Notice of Intent

Sundry ID: 2870062

Type of Action: APD Change

Variance Request for Offline Production Cementing

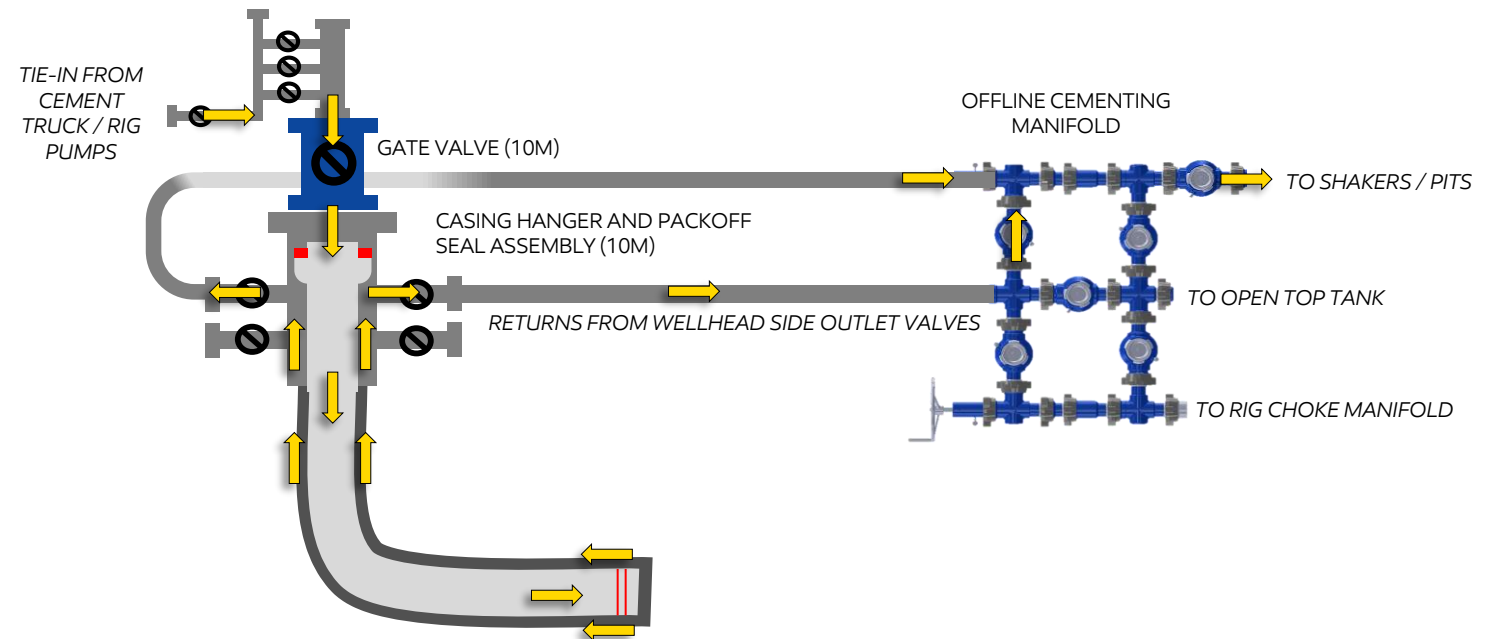
1. Rig BOP replaced by gate valve and WH adaptor assembly (10M rated)
2. Addition of offline cementing manifold and high pressure iron to direct fluid returns to rig active system and/or choke manifold
3. Packoff annulus barrier in place and tested prior to cementing operations (10M rated)
4. Cement truck performs cement job displacement (vs rig pumps)
